BZA Application Form

BZA Number: 165327

LOCATION OF PROPERTY: 27 Fayerweather St., Cambridge, MA

Petitioner seeks to increase height of roof of both the accessory dwelling unit structure and the existing garage.

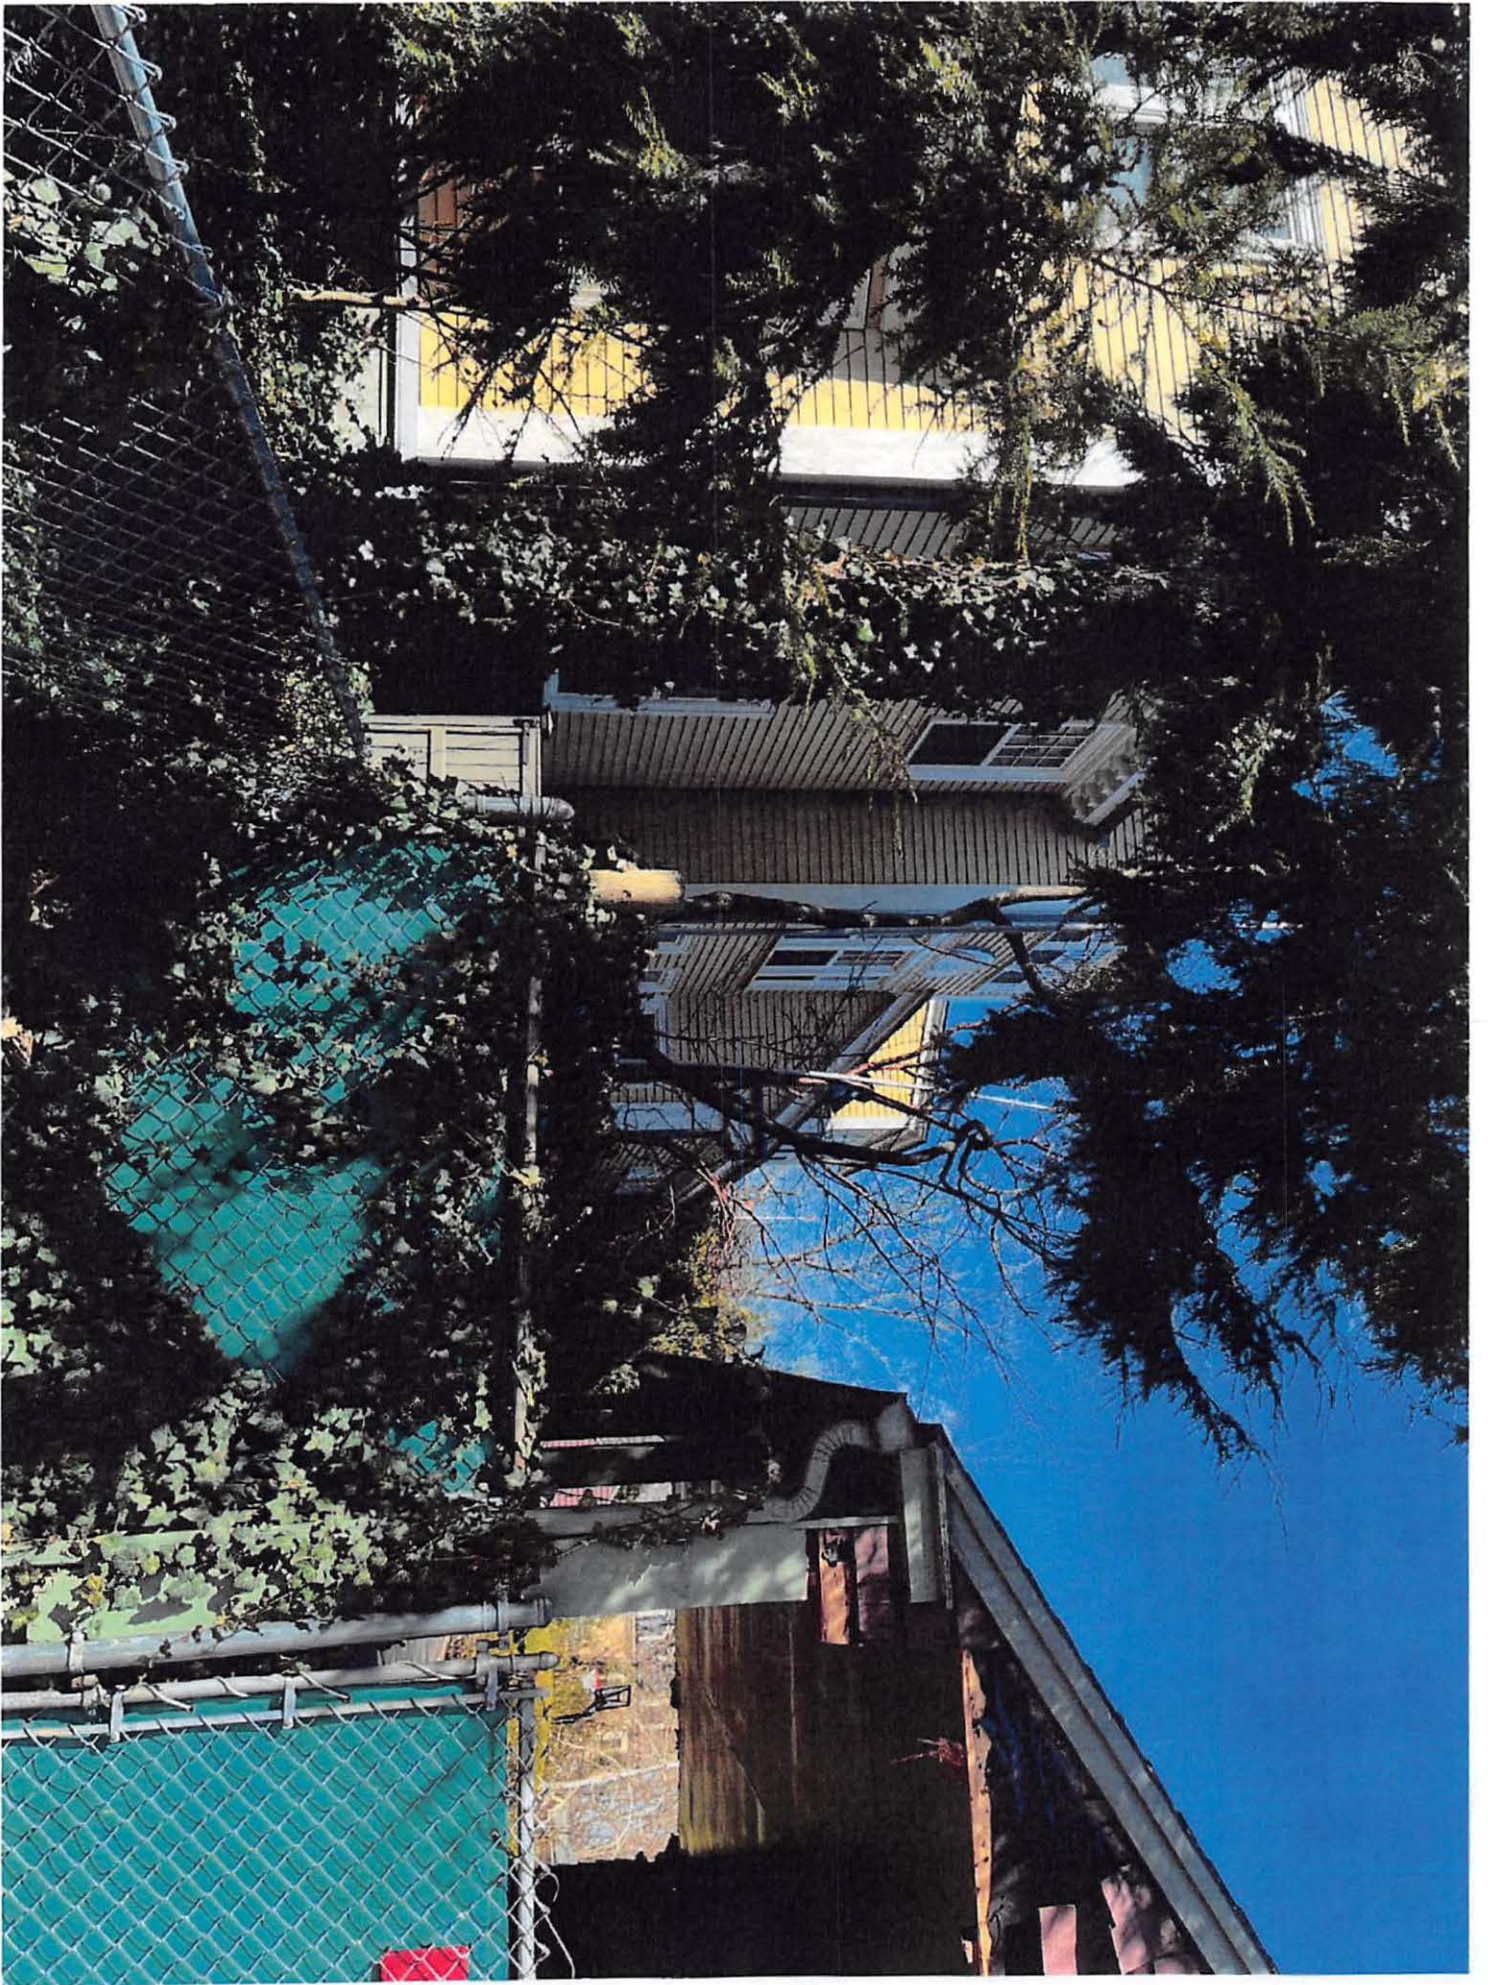
Included are 2 photos of the back corner of our property to show the tall trees, and our sitting area that sits directly next to a new dwelling. The 22' poles our neighbors put up to show the 22" height are visible in these images as is the current brown garage.
